# DOCUMENT CHANGE REQUEST

DCR number 117 Changes required for: N/A

Title: Resistors Heaters Flexible Single and Double Layer, Follow-up Specification for ESA/SCC Detail

Number: 4009/002

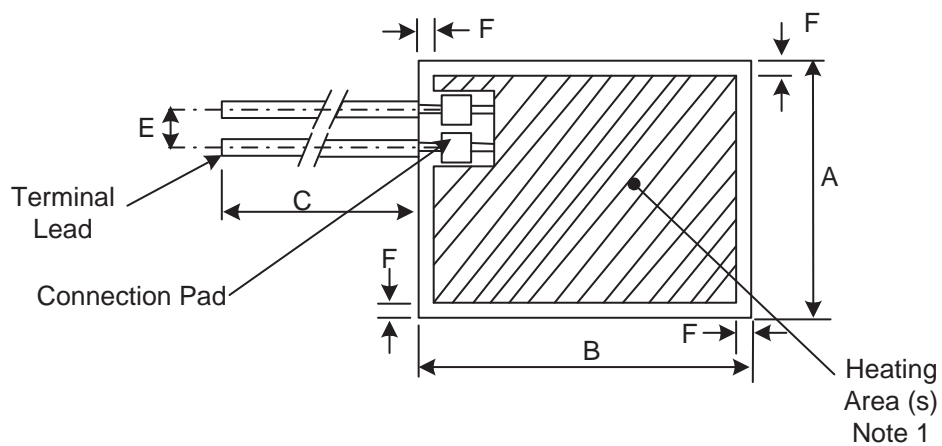
- 1) Rewording and restructure of various sections of the specification - for the purposes of simplicity, consistency and clarification.
- 2) Addition in para 2 and para 4.4.2 of applicable document ASTM-D5213 which supersedes the obsolete MIL-P-46112.
- 3) Deletion of any redundant paragraphs and text. e.g. Functional diagram, Parameter derating figures, electrical test circuits, burn-in circuit figure, etc.
- 4) Clarification in Max ratings Table 1(b) and Dimensions Figure 2, of the definition of heating area (s) (to exclude the

peripheral margin & terminal connection area).

5) Delete dimension 'D' requirement and add notes to Figure 2 to allow terminal leads to exit the terminal connection area at any angle, plus define the lead spacing (Dim. 'E') to be measured at the terminal connection area. The position of the connection pads, and hence leads, is now only limited by the peripheral margin (Dim. 'F'). The new RICA/Nicolitch lead attachment process allows more flexibility in the positioning and aspect of the terminal leads whilst maintaining mechanical and material integrity.

2. The tolerance shall be  $\pm 10\%$  on the required dimension.
3. The tolerance shall be  $\pm 0.5\text{mm}$  on the required dimension.
4. Terminal lead spacing shall be measured at the terminal connection area. Terminal leads may exit the terminal connection area at any angle. The terminal leads may be located on any side of the heater. There may be more than 2 terminal leads (for multiple resistive element and double layer heaters).
5. Peripheral margin dimension of the finished product.
6. Perforated holes in the peripheral margin are allowed provided that the distance between the edge of hole and the heater element or connection pad is equal to, or greater than, dimension F.
